DA Assessment Report

Development application assessment report for Deniliquin Council DA 06/15 for the proposed construction of a new Police Station facility at Lot 13 Section 1 DP758913, 405 Charlotte Street and Lot 2 DP556329, 402 Riverside Drive, Deniliquin.

JRPP NO: 2015WES002

SUBJECT: CONSTRUCTION OF A POLICE STATION FACILITY

PAPER CCG PRAWING DA-03 WITH MARK-UP DEMILIQUIN HEATTAGE ADVISOR/HOEL THOMAN MARKEN 2015

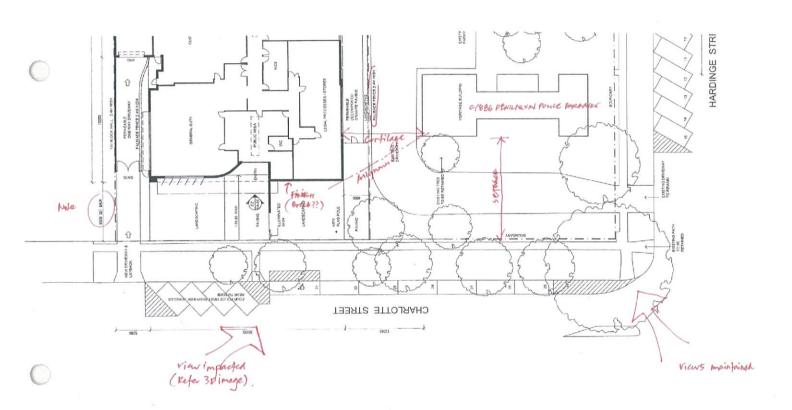
Noel Thomson also notes that on review of the drawing that there is a 9m setback to the new Police Station which is forward of original heritage listed Police Barracks building. This has an impact on the views to the Police Barracks building when in front of the new Police Station which is evidenced by the perspective view at the start of this Report. Other issues that impact on the original heritage listed Police Barracks building is the height of the shed 5.5m high directly east of the building – further information to be sort as to why so high. Finally recommendation is for the front of the new Police Station to have a sympathetic finish to the former Police Barracks building and that it be constructed in <u>red</u> brickwork rather than a 'modern' terracotta facade as currently proposed.

NOTE: PREPENCE NOUND BE FOR NEW BUILDING TO BE SETDACK BEHIND THE "HEALTHAE ITEM" BUT NOTE SITE CONSTRAINTS AND THEALTHAE NEW BUILDING IS LAUGHTED FORWARD. DOES HAVE MINOR IMPACT WHIN VIEWED FROM CHARLOTTE STREET.
